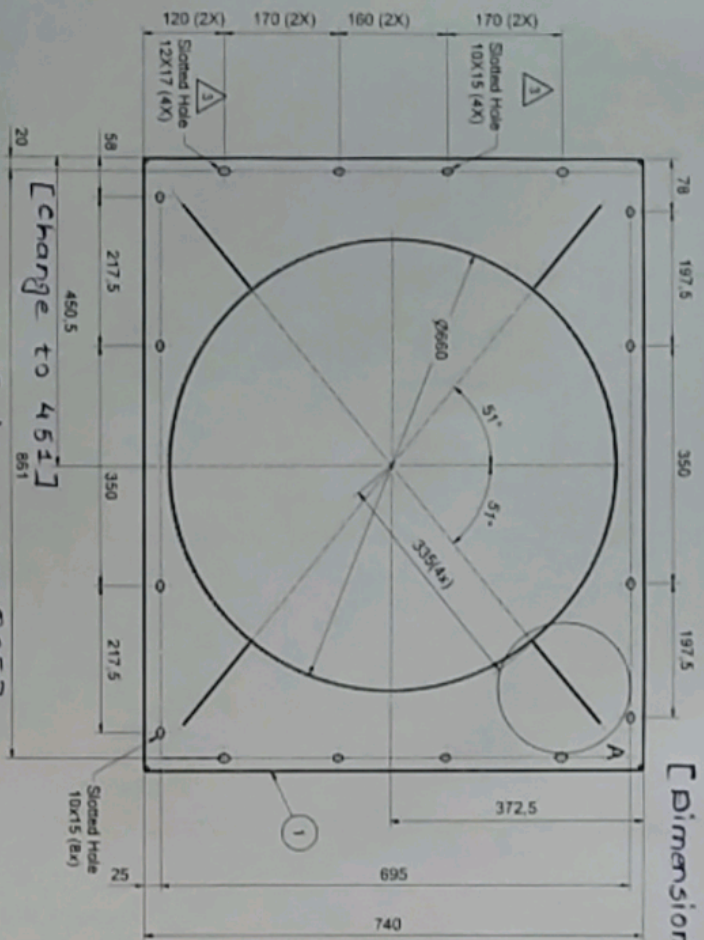
[Datum 'A' is
not specified]

[Change to 865]

[Dimension missing]

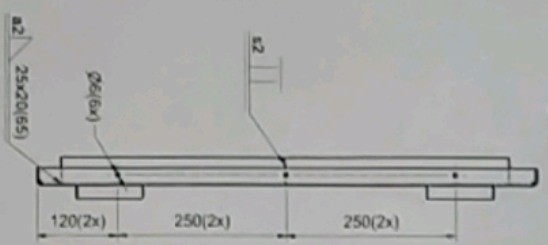
[Dimension
overwritten]

[Add welding
details]

[Add detailed-view
description]

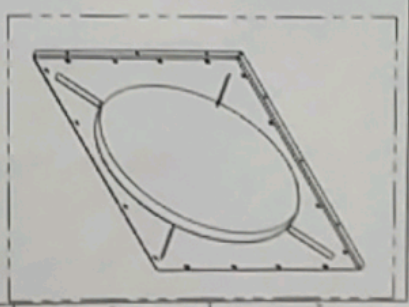
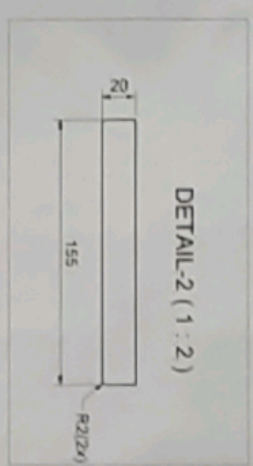
[2 no.
part not
specified]
